# Technical Service Information

## FORD E40D CONVERTER CLUTCH SHUTTER

Figure 1

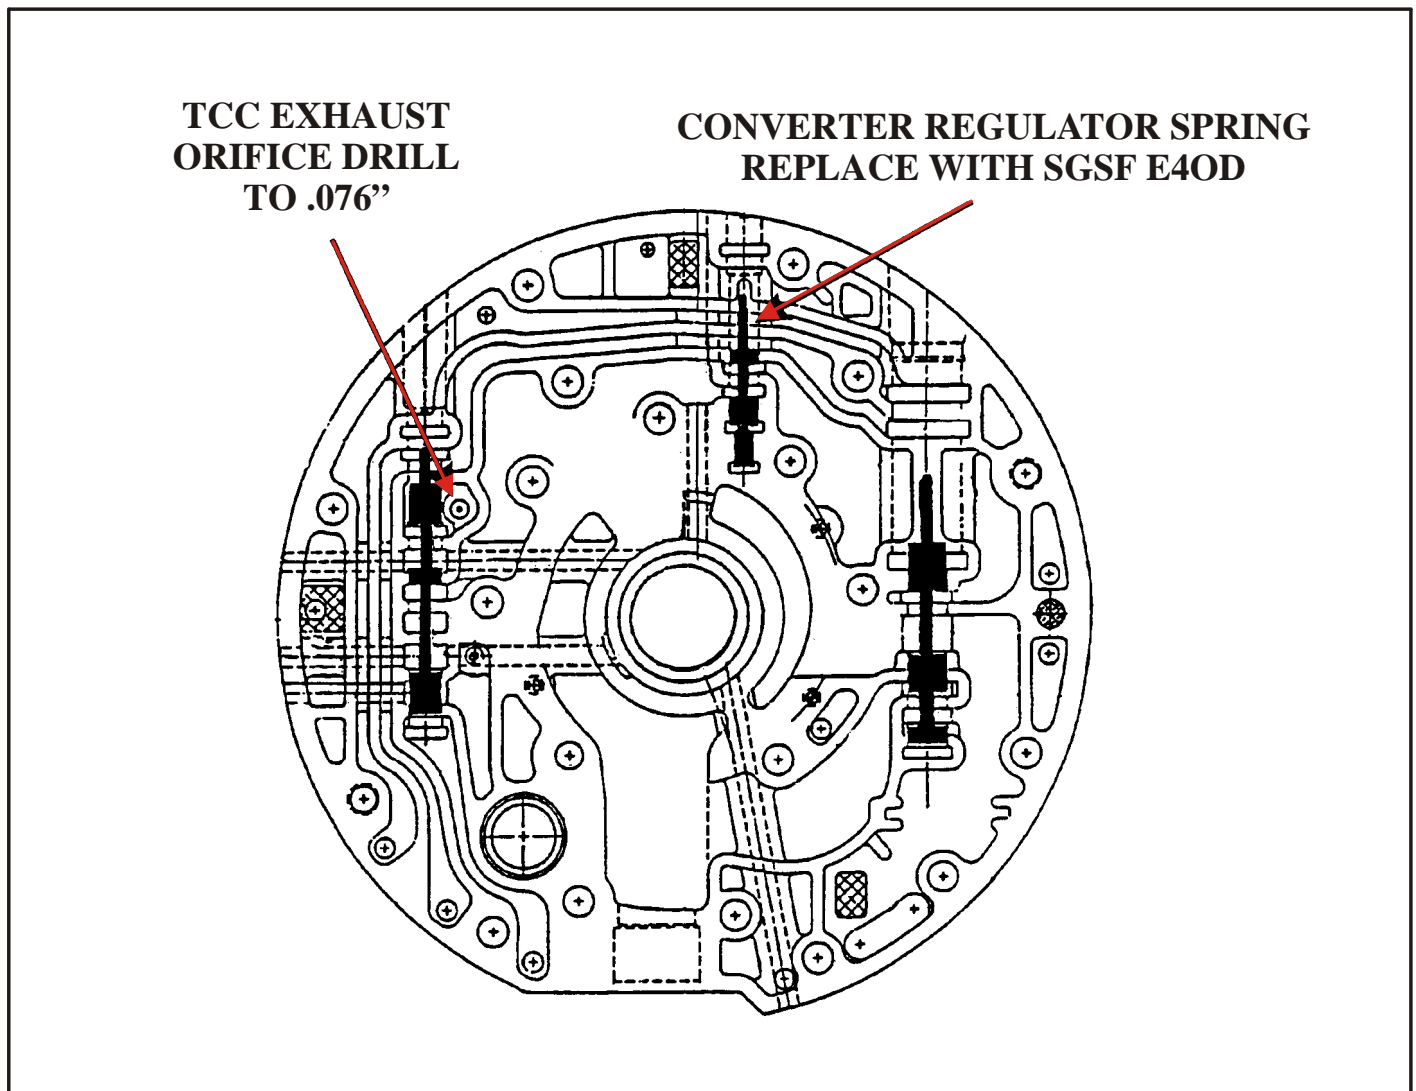
**COMPLAINT:** Soft converter clutch engagement or shudder on hard acceleration

**CAUSE:** Low converter pressure and/or limited ability of the converter exhaust orifice to control converter clutch apply.

**CORRECTION:** Replace the converter regulator valve spring in the pump cover with a “SGSF E40D” shudder fix spring (see figure 1), Drill the converter clutch exhaust orifice to .076 in. (see figure 1).
